Interested Party:	Kitikmeot Inuit Association (KIA)	TRC NO.:	KIA-NIRB-01
Re:	Wind Turbine Height Differences and Implications

B2Gold’s Response to Request Provided on June 15th, 2023:

Figure 2.3-6: Raptor Cliff Nest Locations and Habitat Suitability from the Back River FEIS

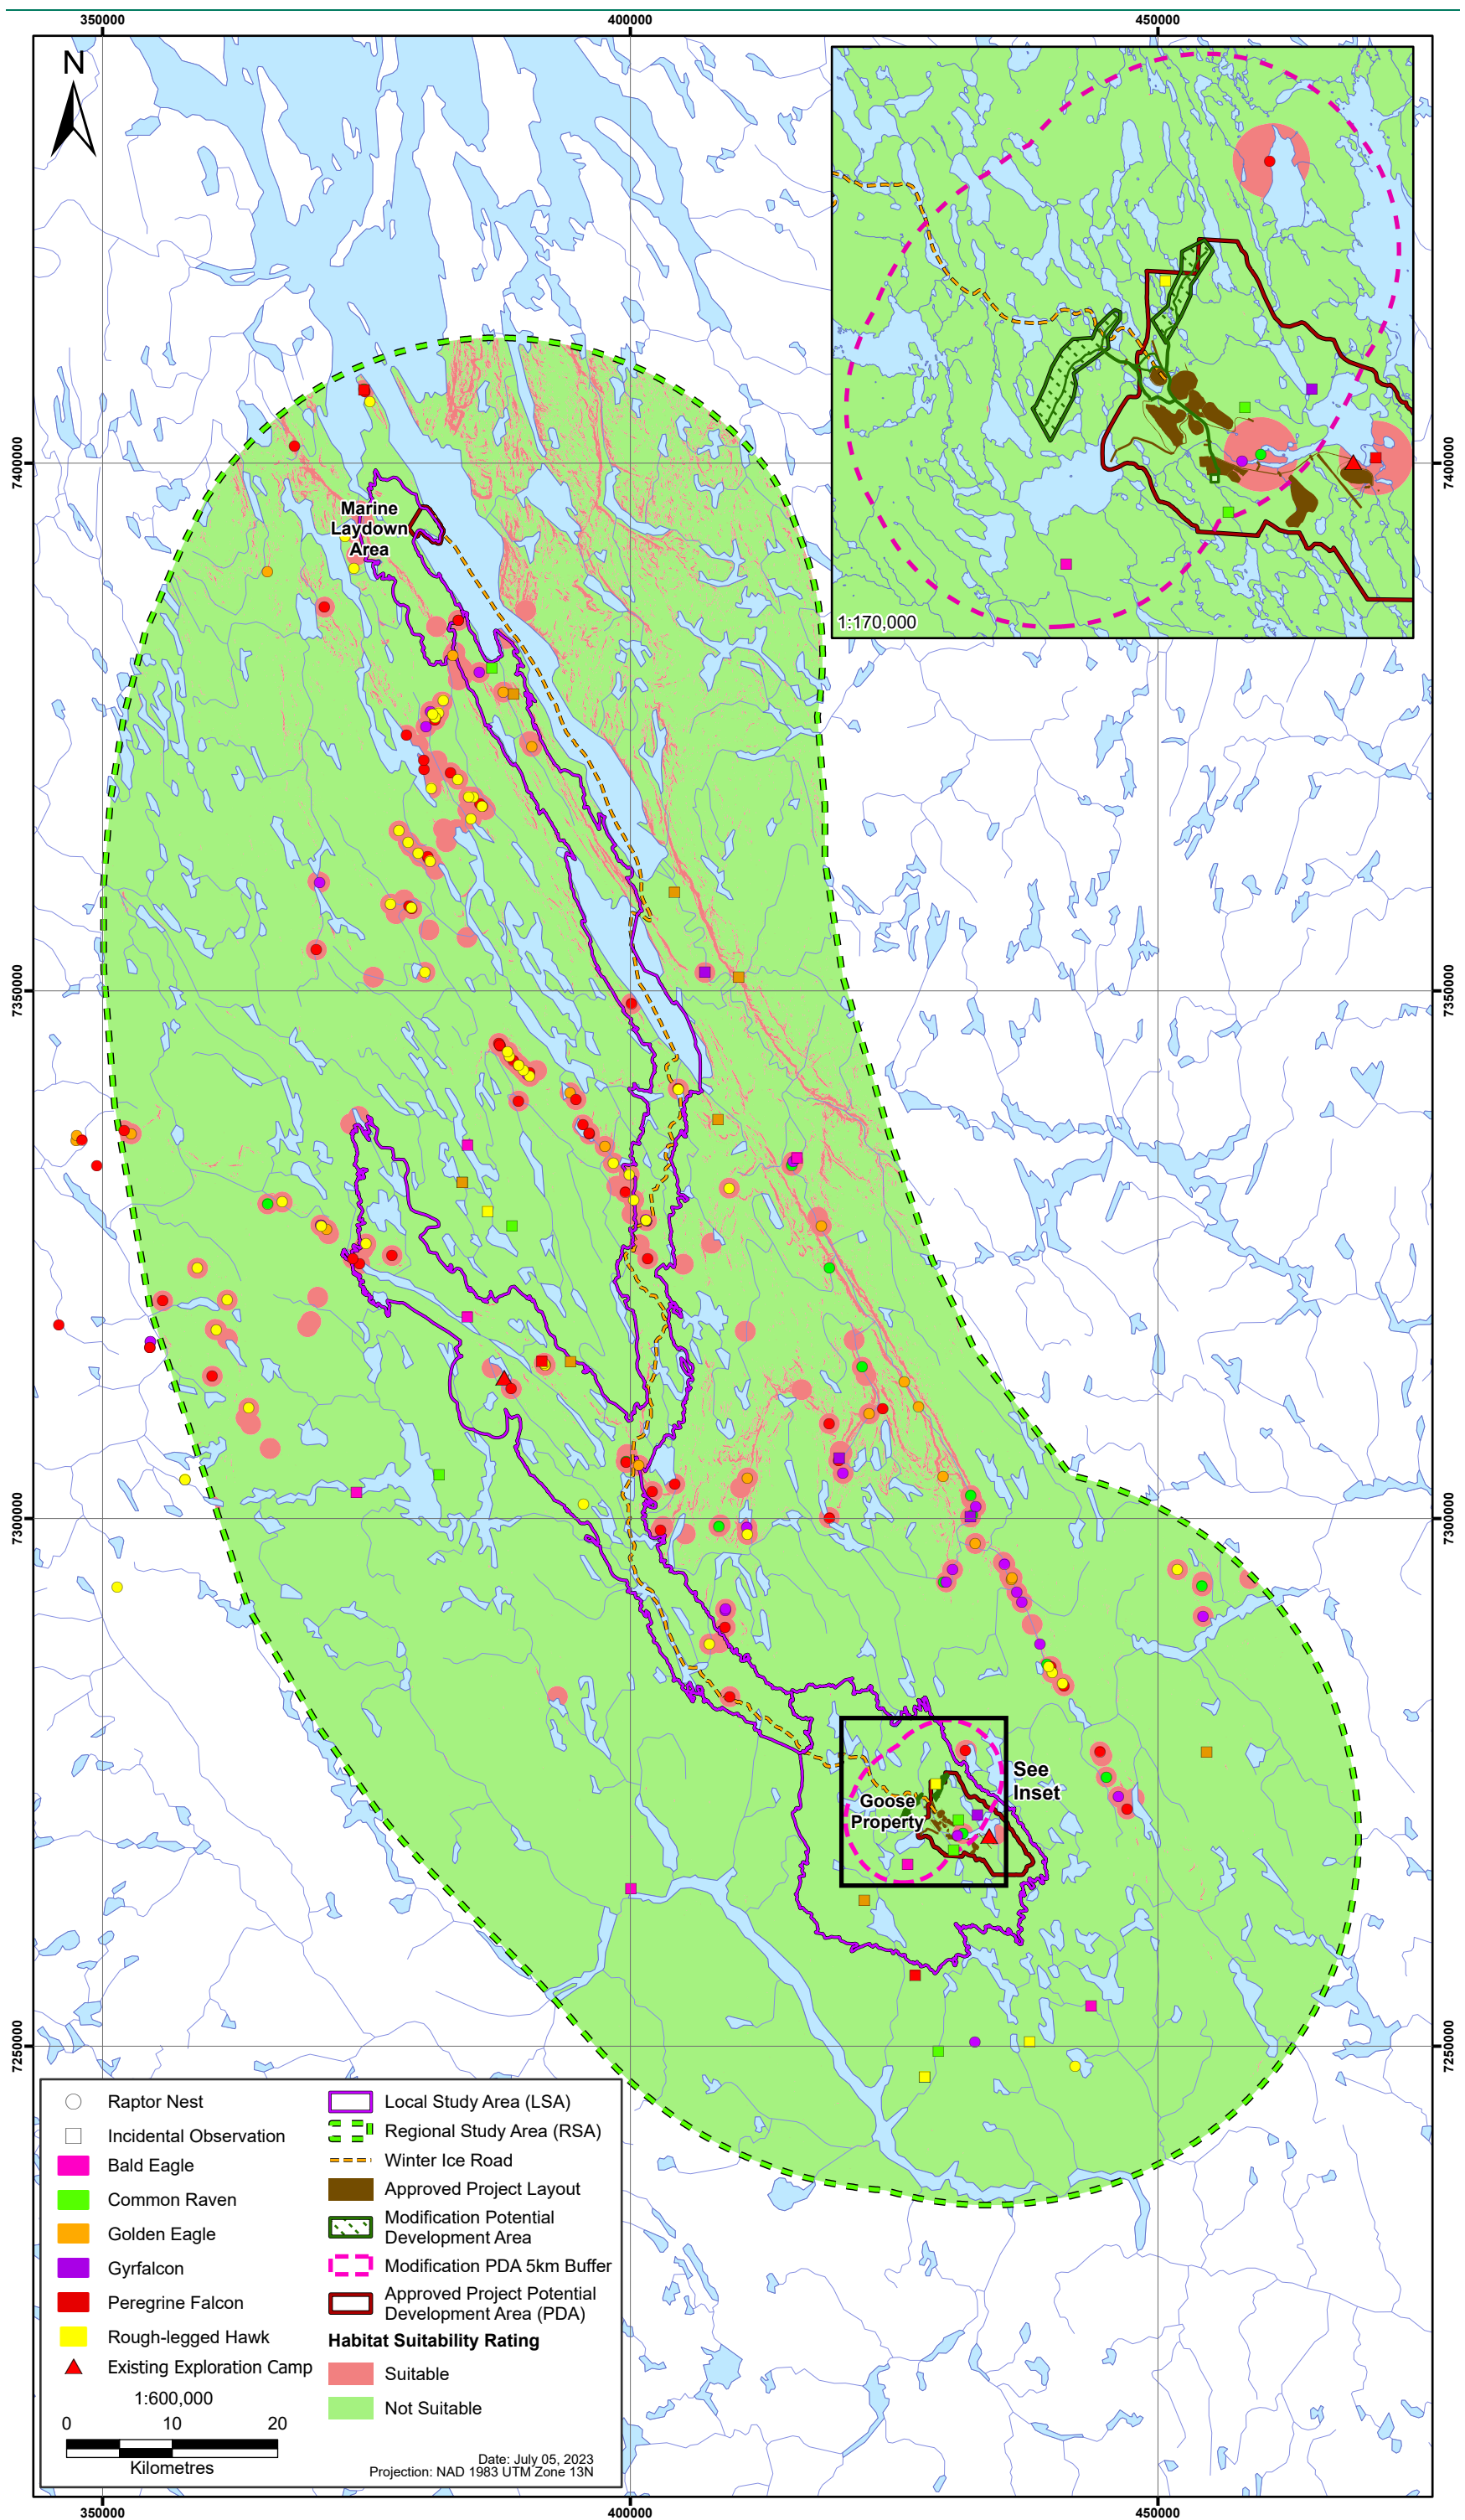
- Please update the maps in Figures 2.3-6 and 2.3-7 to include all symbology and clearly display the raptor nests found within 5 km of the Modification PDA in the inset maps.
- Please commit to increasing the buffer distances for nesting waterbirds, upland birds, and raptors if birds exhibit disturbance behaviours at the current distances listed in the WMMP Plan V.12.

- Updated maps showing all raptor nests within 5 km of the Modification PDA are appended below. No ground-nesting raptor nests have been observed within 5 km of the Modification PDA, and one peregrine falcon nest was observed approximately 3 km from the Modification PDA, and one gyrfalcon nest approximate 4 km away (within the Goose PDA), both observed more than 10 years ago. As stated in Section 2.3.7.4, aerial surveys will be conducted prior to construction to confirm current cliff-nesting raptor nest locations and occupancy status. In addition, the east Modification PDA is within the Goose PDA; therefore the habitat was already considered lost in the FEIS. As stated in Section 2.7.3.4 of the FEIS Addendum, "The potential for loss of ground-nesting habitat was evaluated for the area where the Modification footprint extends beyond the Goose PDA." And "The Modification footprint is primarily contained within the Goose PDA; therefore, very little additional habitat loss is expected beyond what has already been assessed and permitted."
